**PIKES PEAK AREA COUNCIL OF GOVERNMENTS**

**Date:** December 12, 2002  
**Item Number:** Continuing Business - Item #8  
**Item Name:** Noise Wall Options Along I-25 and Monument Valley Park

**Parks, Recreation and Cultural Services**  
**Colorado Springs Utilities**  
**Final Recommendations**  
**I-25 and Monument Valley Park**  
**- Proposed Noise Mitigation Measures -**

### I - 25 Sound Mitigation Proposals For Monument Valley Park

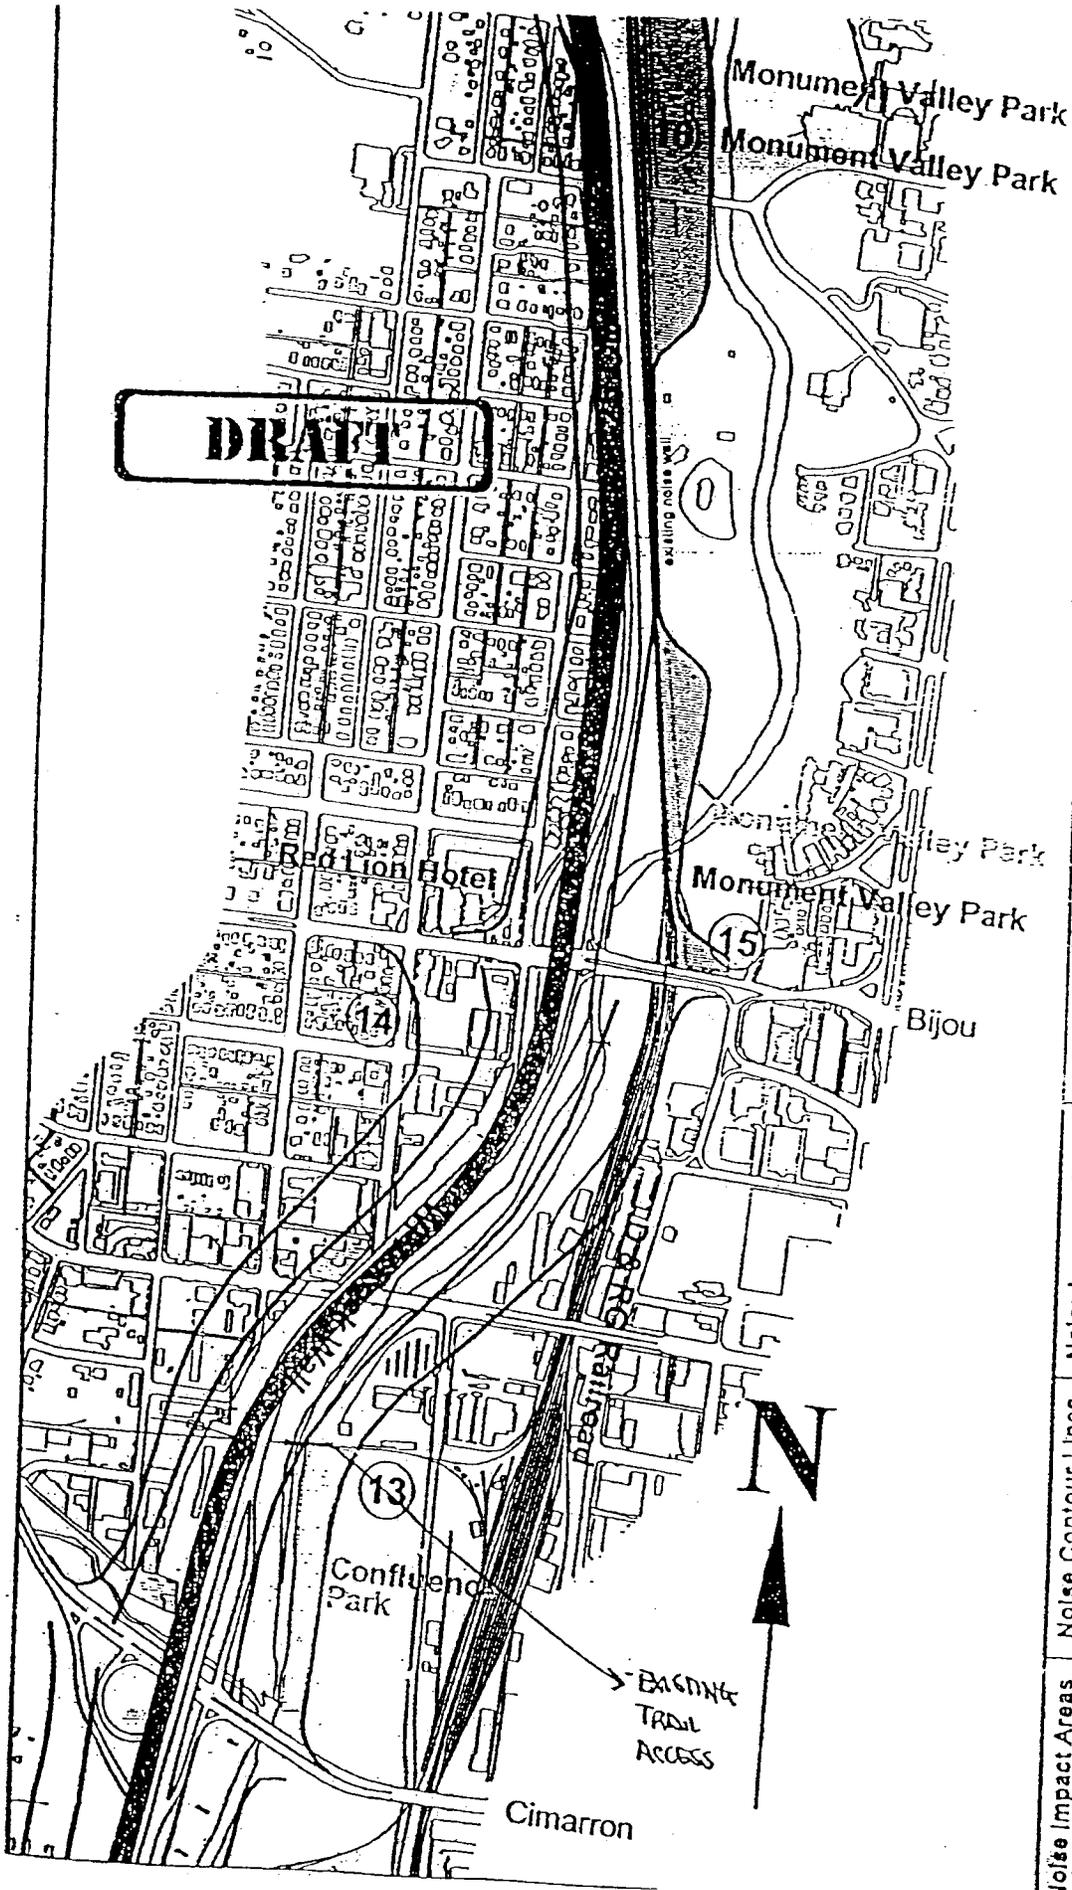
1. The interstate will probably be twenty feet above the general elevation of the park.
2. Because of the topography adjacent to the east side of I-25 (steep drop-off) any noise wall would have to be directly attached to the highway shoulder. For the most part, the highway will be cantilevered through this section.
3. In order to be effective, the noise wall would need to be fifteen to twenty feet high to provide the required 5 dB(a) noise reduction. The wall would also need to extend past the ends of the park to avoid the noise going around the wall.

In looking at these facts, and relying on one of the basic design tenets of this park (that it be visible from the interstate), staff rejected the notion to pursue further work on a potential noise barrier. City staff did ask if any design features for this section were available to might help deaden noise, particularly tire noise. One suggestion made by Wilson and Company was that the safety barriers (guard rails) could be designed to have no open space between the support posts. An additional thought was to use the traditional concrete jersey barrier as a sound-deadening feature. Wilson staff indicated that typically these safety barriers were approximately three feet high, which would allow for viewing into the park, but would provide only a 1dB(a) noise reduction.

City staff felt that the views into and out of the park where of much higher importance to the visual quality of Confluence Park than the noise reduction issue. Staff's feedback to Wilson was to involve the City in the design process when it came time to work on the safety barrier aspect of the interstate.
